CAMPAIGN BULLETIN

Rear Combination Lamp Dealer Inventory

Reference: PC746

Date: December 4, 2020

Exploded View

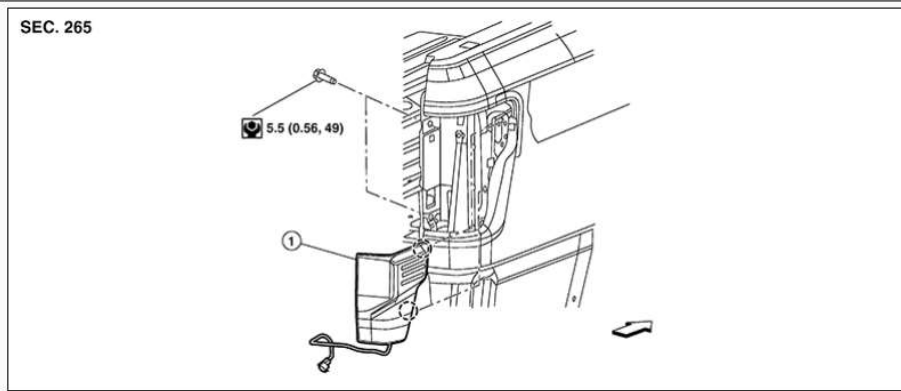
1. Replace both rear combination lamps.
 - Refer to the Electronic Service Manual (ESM) procedure for removal and installation of the rear combination lamps. **DRIVER CONTROLS - EXTERIOR LIGHTING SYSTEM - LED HEADLAMP - REMOVAL AND INSTALLATION - REAR COMBINATION LAMP**

1.	Rear combination lamp	⊙	Pawl	←	Front
----	-----------------------	---	------	---	-------

NOTE:
RH shown, LH similar.
